Dominion Nuclear Connecticut, Inc.
Millstone Power Station
Rope Ferry Road
Waterford, CT 06385

Serial No.: 04-720
LR/ELA R0
Docket Nos.: 50-336
50-423
License Nos.: DPR-65
NPF-49

DOMINION NUCLEAR CONNECTICUT, INC. (DNC)
MILLSTONE POWER STATION UNITS 2 AND 3
RESPONSE TO REQUEST FOR ADDITIONAL INFORMATION
LICENSE RENEWAL APPLICATIONS

Figure 1
Millstone Unit 2
Containment Tendon Prestress
Dome Tendons
(Raw Data)

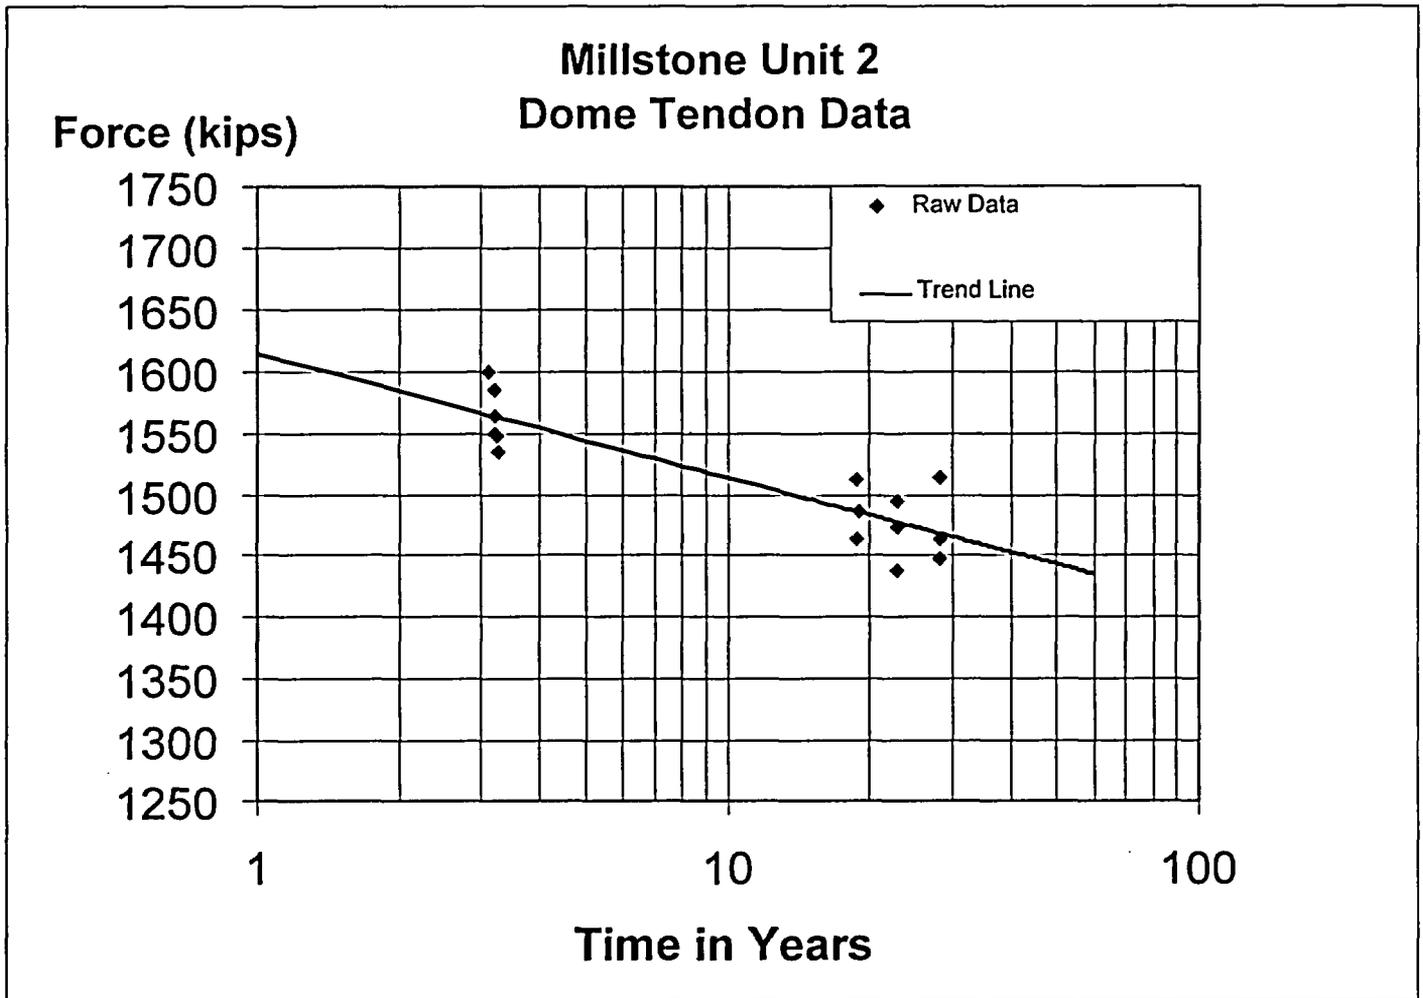
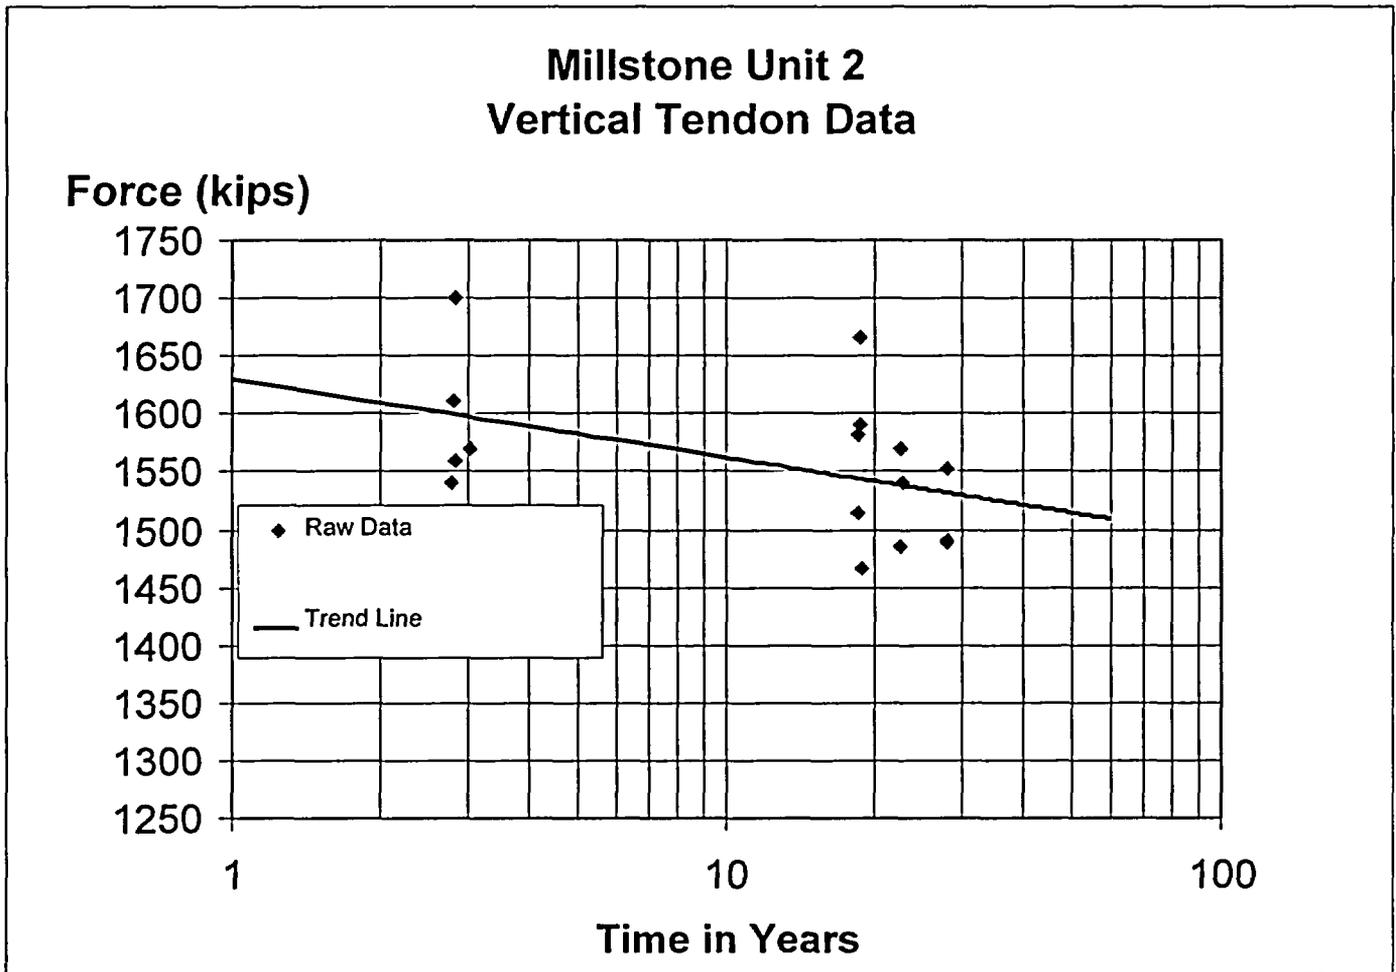
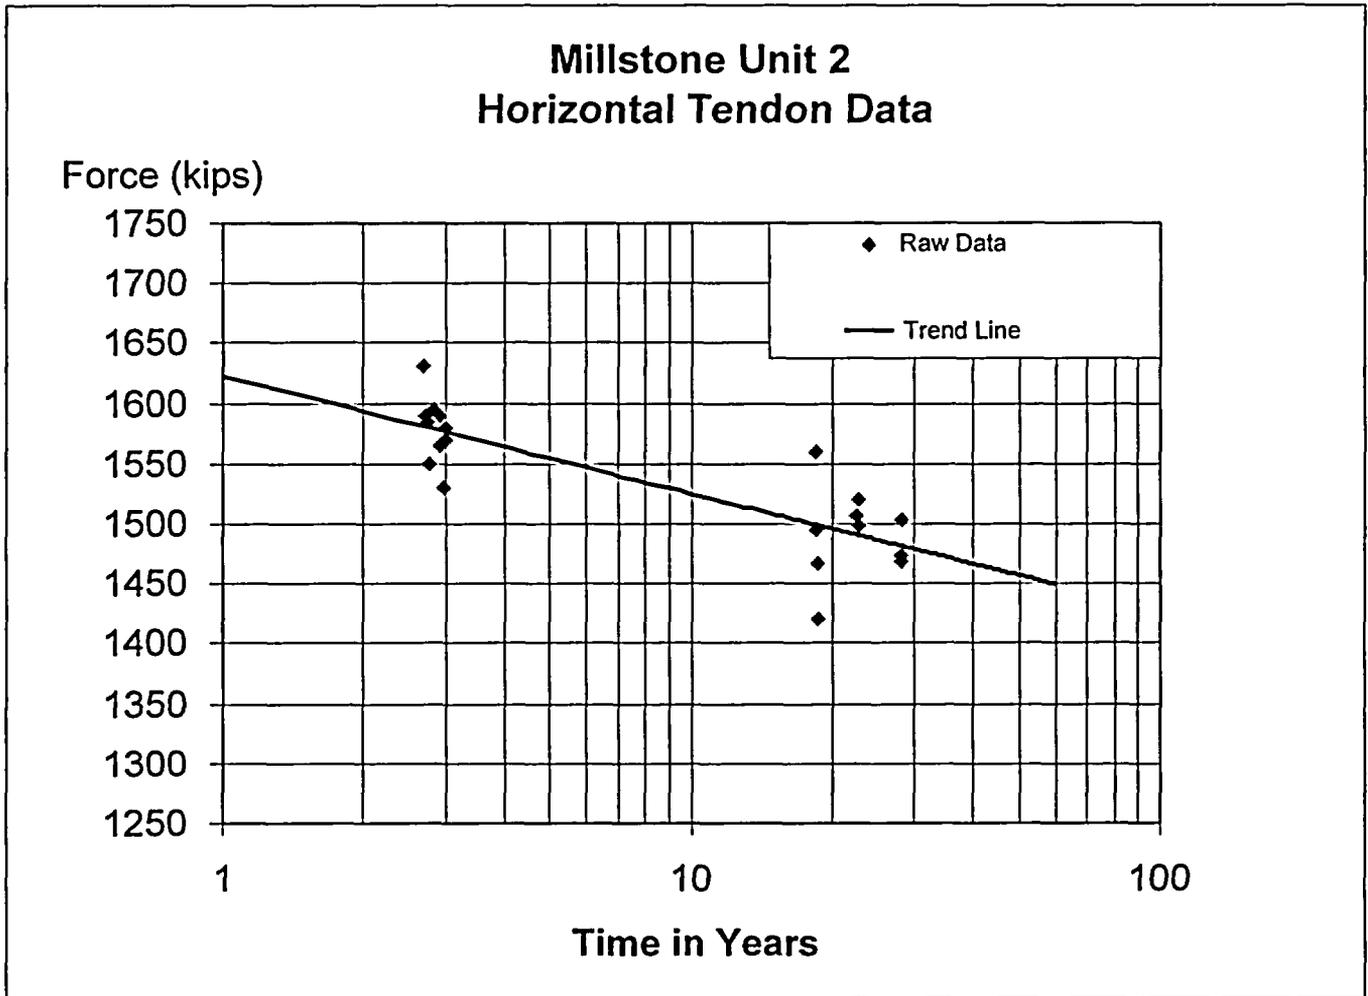
As presented in the responses to RAI 4.5-4 (Figures 1, 2 and 3) and RAI 4.5-5 (Figures 1, 2 and 3), projected lockoff forces (Millstone Unit 2 LRA, Section 4 – Figure 4.5-1) remain above minimum requirements over the period of extended operation.

As a supplement to the regression analysis results contained in the response to RAI 4.5-5, the raw dome, vertical and horizontal tendon force data contained in Tables 1, 2 and 3 was used to develop the indicated best-fit trend-lines in Figures 1, 2 and 3. Tendon force data developed in accordance with Regulatory Guide 1.35, Revision 1 requirements (3, 5 and 10-year inspections) was not used for trending purposes since this revision required repetitive detensioning and retensioning of the same tendon groups. Prestressing forces for the 15, 20 and 25-year containment tendon inspections were developed using the requirements of Regulatory Guide 1.35, Revision 3. Only prestressing forces from previously untested tendons are used for projection purposes.

Figure 1
Millstone Unit 2
Containment Tendon Prestress
Dome Tendons

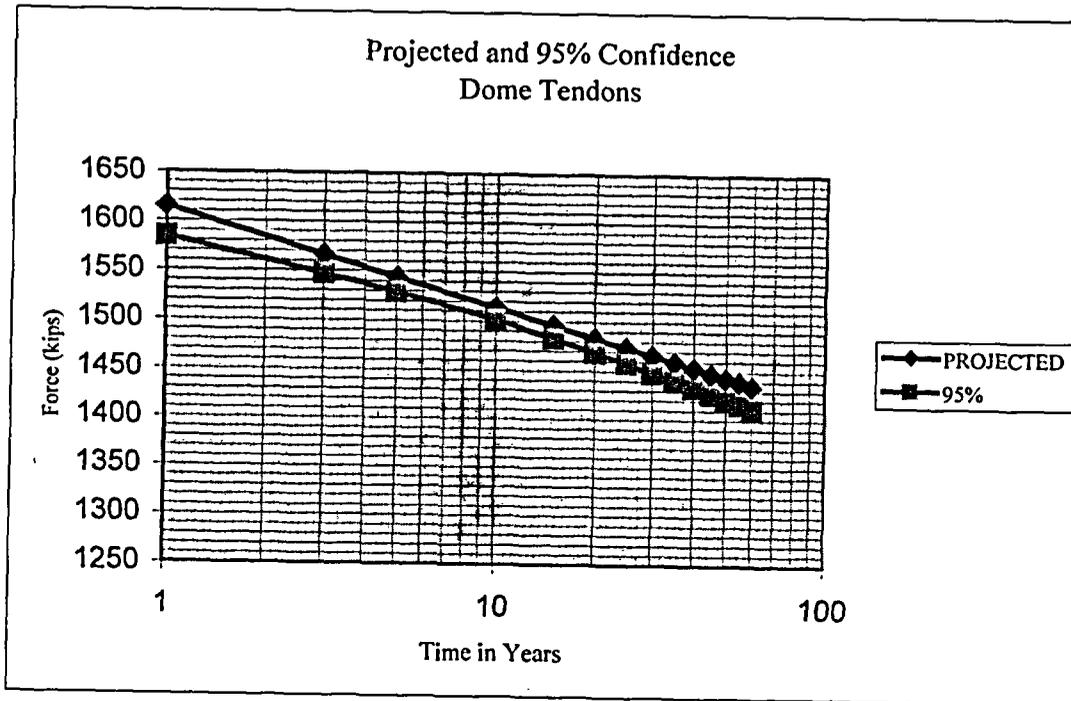
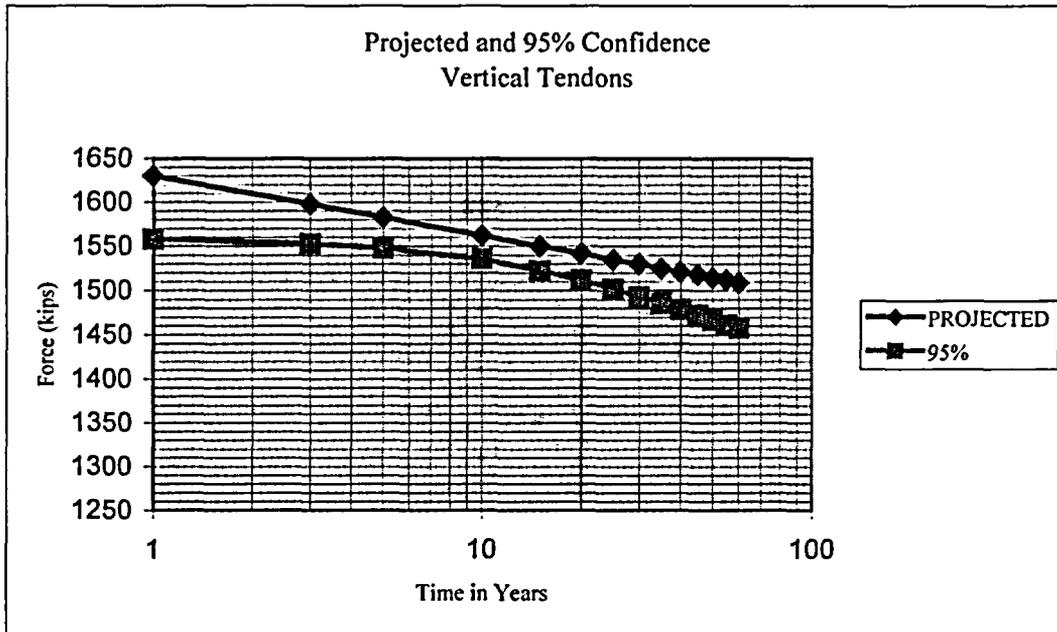
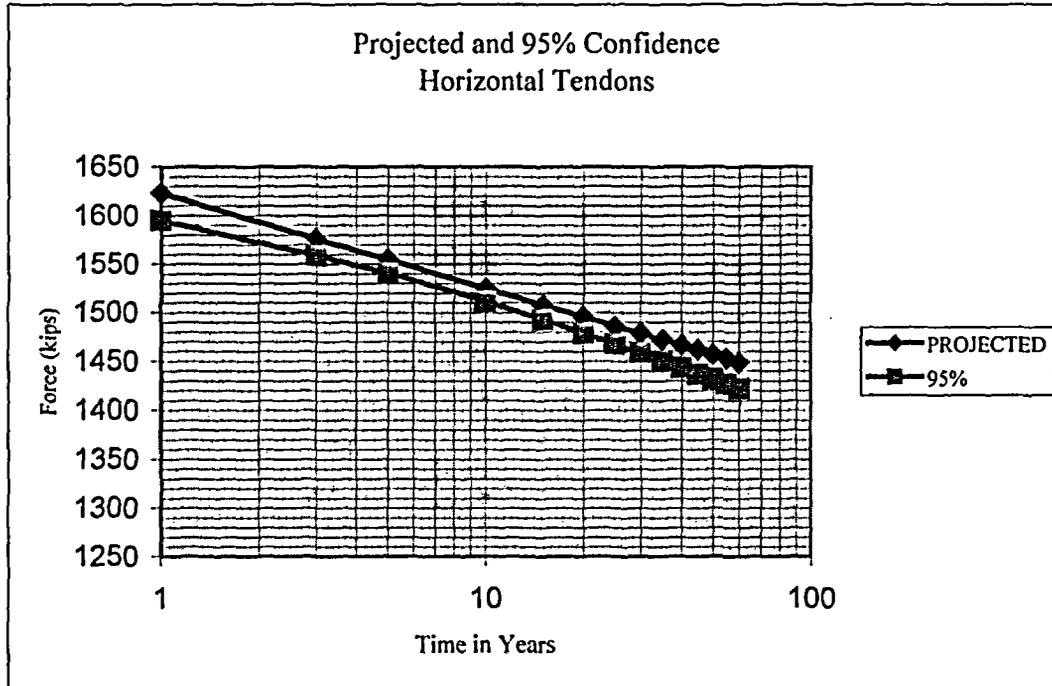
The process used by the license renewal applicants with prestressed concrete containments, is to assume that the tendon force varies with the logarithm of time (as explained in Regulatory Guide 1.35.1). It is not apparent in figure 4.5-1, what functional relationship has been assumed between the two variables. The applicant is requested to provide additional information regarding the process used in arriving at the trending curves shown in Figure 4.5-1.

Consistent with Regulatory Guide 1.35.1, the containment dome, horizontal and vertical tendon surveillance results (Millstone Unit 2 LRA, Section 4, Tables 4.5-1, 4.5-2 and 4.5-3) used in the development of LRA Figure 4.5-1 have been plotted in the following Figures 1, 2 and 3, against the logarithm of time using the methodology identified in Attachment 3 of NRC Information Notice 99-10. Prestressing forces for the Millstone Unit 2 containment dome, horizontal and vertical tendon are shown to vary linearly with time. Further discussion and information on the development of these curves can be found in the responses to RAI 4.5-2, RAI 4.5-4 and RAI 4.5-7.
